Subject: Agoura Village Specific Plan; Notice of Preparation of Draft EIR

SUBJECT: Review of Document 05-011 Agoura Hills Village Specific Plan
Notice of Preparation of an EIR for the Agoura Hills Village Specific Plan encompassing approximately 587,000 SF of retail and office space and between 184 and 234 residential units. The project is located on the south of 101 Freeway and on either side of Kanan Road in the Agoura Hills in Los Angeles County.
Lead Agency -- City of Agoura Hills

RESPONSE TO NOTICE OF PREPARATION ENVIRONMENTAL IMPACT REPORT AGOURA VILLAGE SPECIFIC PLAN CITY OF AGOURA HILLS

NOTICE OF PREPARATION, THE AGOURA VILLAGE SPECIFIC PLAN, "CITY OF AGOURA HILLS" – (FFER #200500011)

Figure 10.1
SCENIC HIGHWAYS

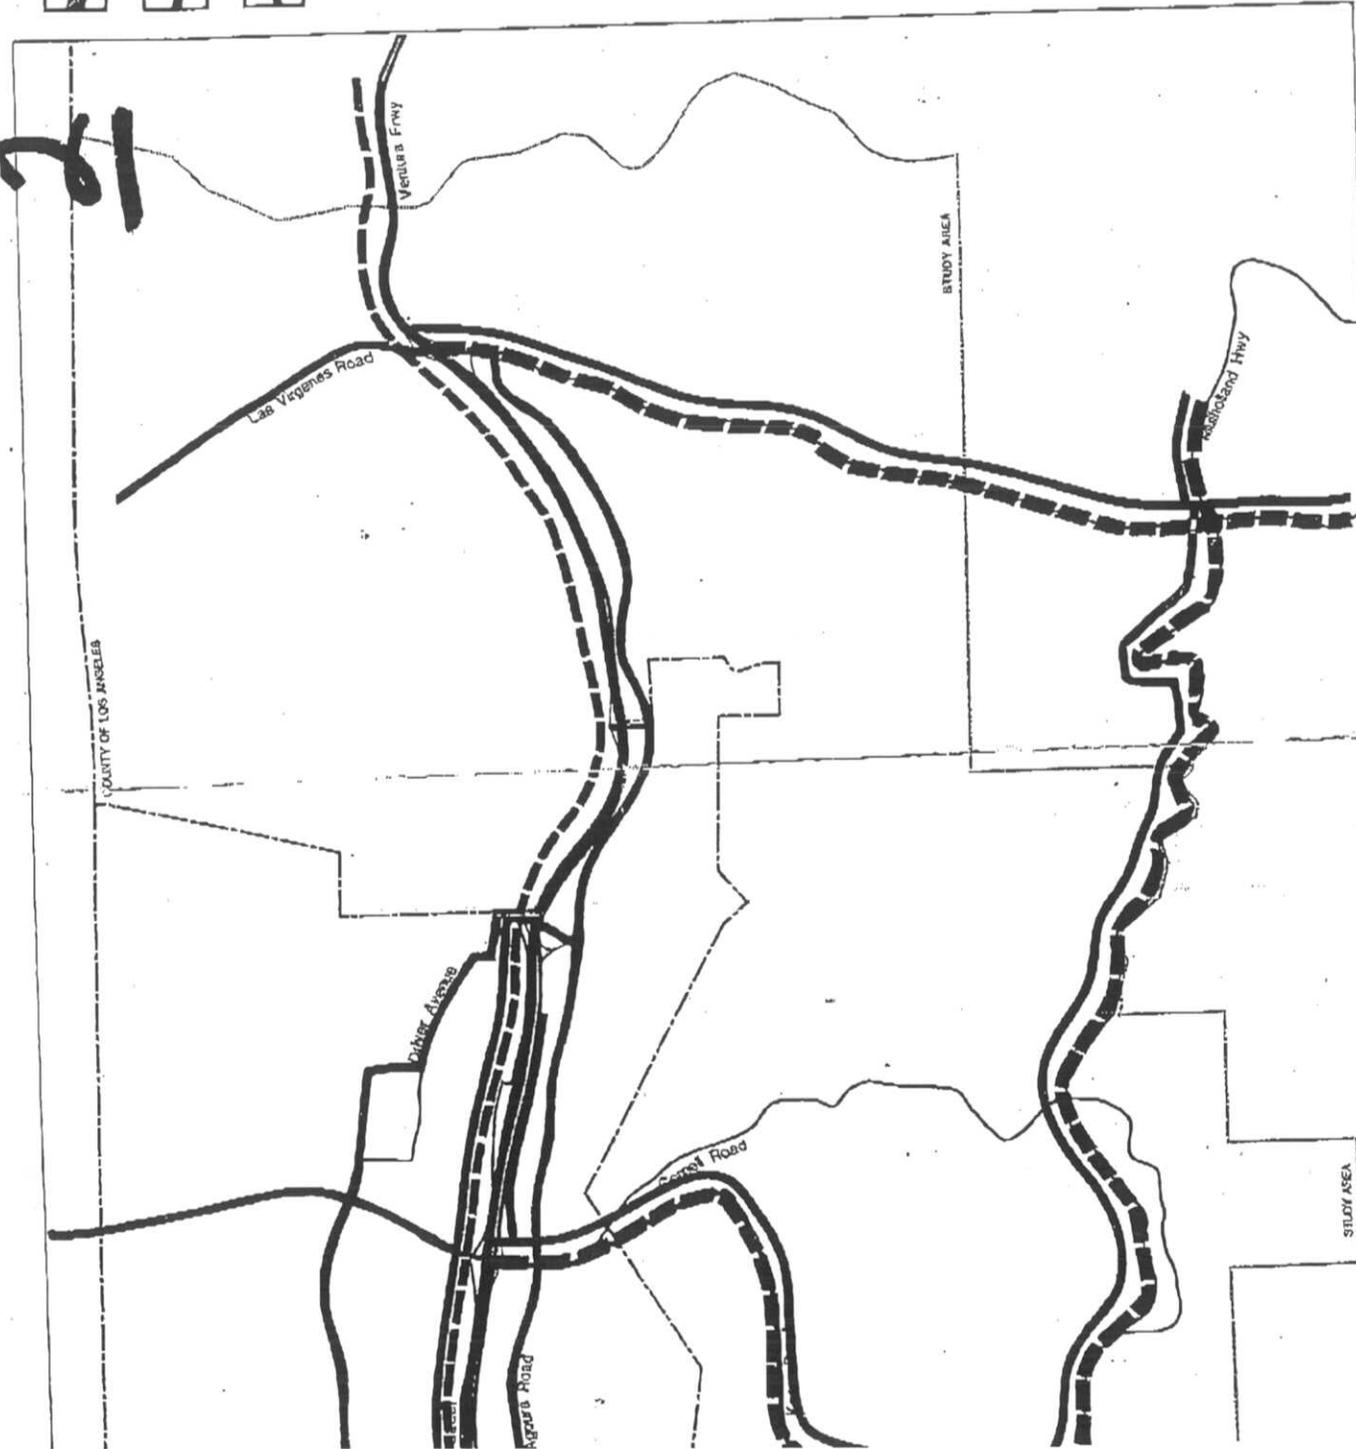
Scenic Corridor Plan. (Map Enclosed) and the Santa Monica Mountains Comprehensive Plan.

Please "reopen" the public hearing to make appropriate changes and vote to:
